Project No. 2628-065  
R.L. Harris Hydroelectric Project  
Transmittal of the Final Operating Curve Change Feasibility Analysis Phase 1 Report

Attachment 2 – Comments and Responses on the Draft Operating Curve Change Feasibility Analysis  
Phase 1 Report

Attachment 3 – Final Operating Curve Change Feasibility Analysis Phase 1 Report

**Figure 5-11 Extent of Flooding at RM 101.7 from Results of 100-Year Design Flood in Harris-Martin HEC-RAS Model**

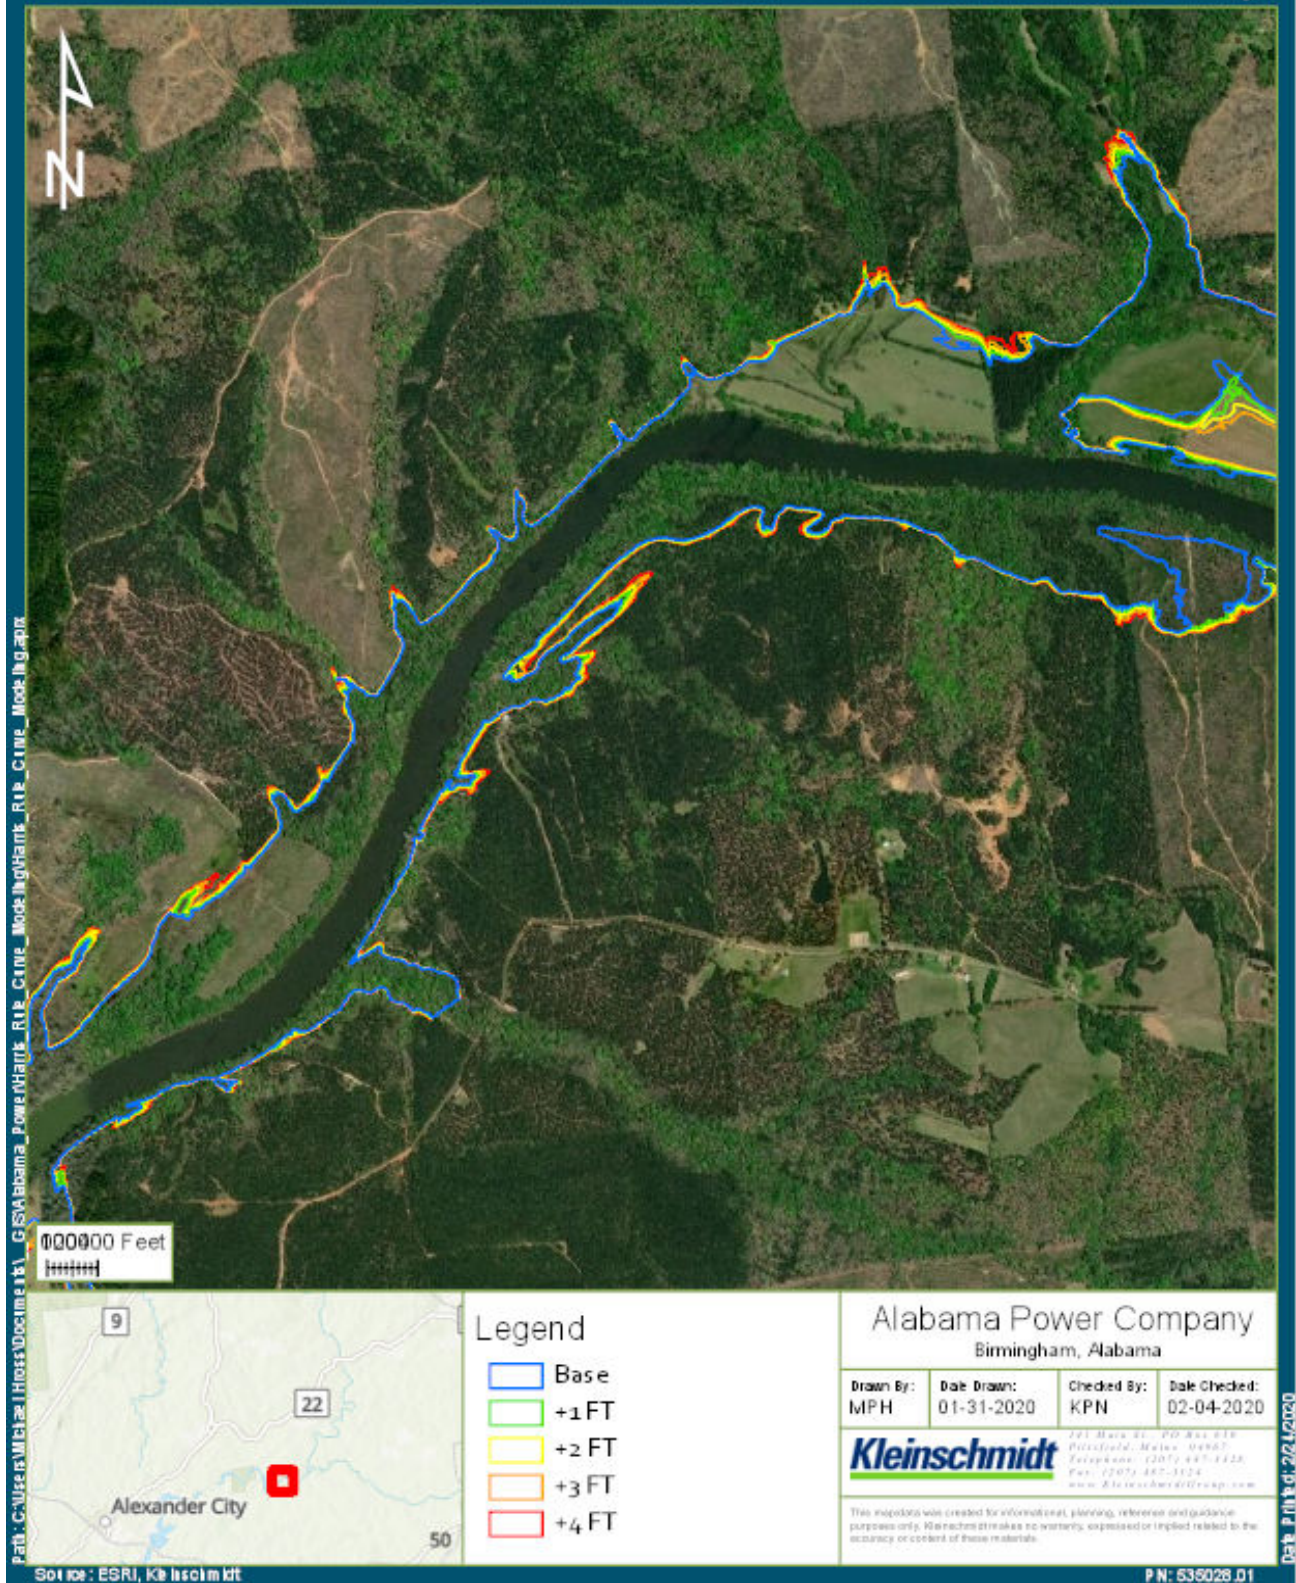
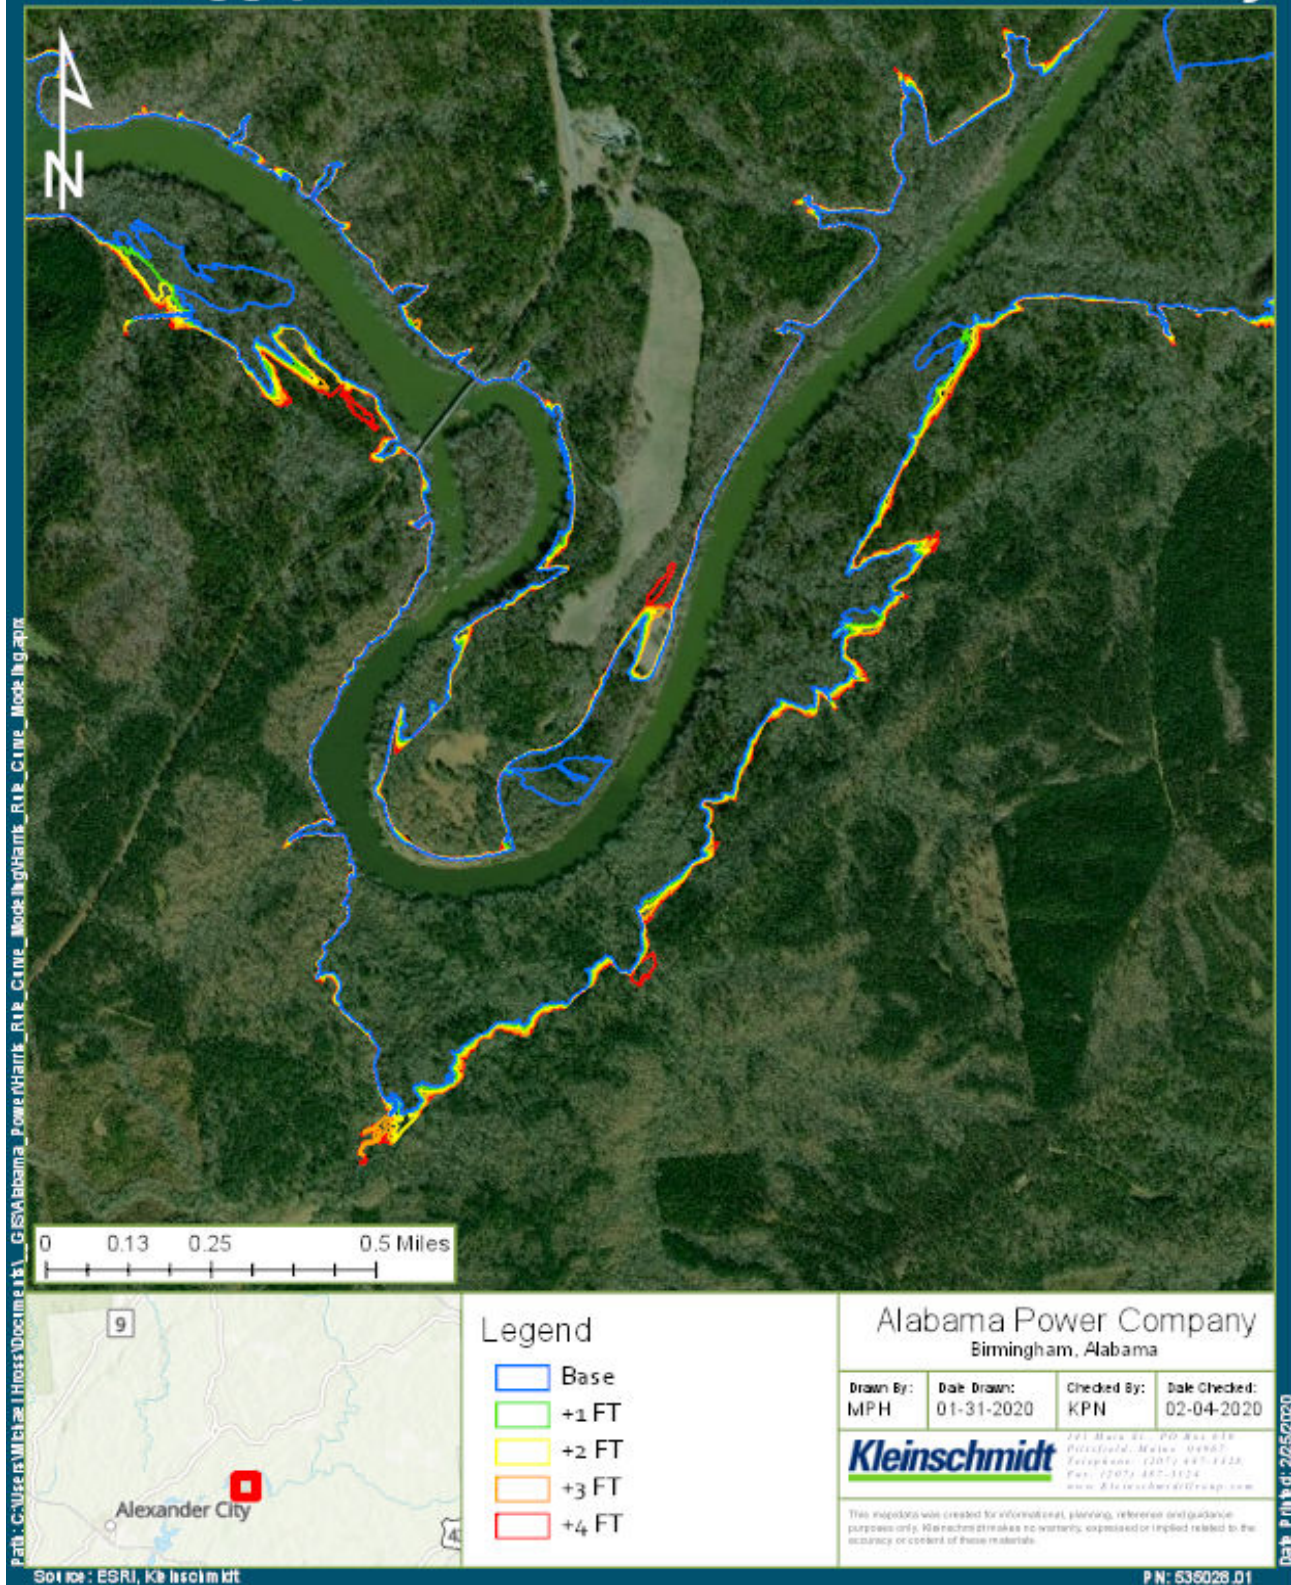
- On pages 45-50, Figures 5-7 through 5-12 of the Operation Curve Change Feasibility Analysis Study visually indicate inundation boundaries for the baseline of four winter pool alternatives. Include a Table with calculated totals of inundated acreages for the baseline and four winter pool increase alternatives to assist with the quantitative evaluation of inundation effects downstream of the dam.
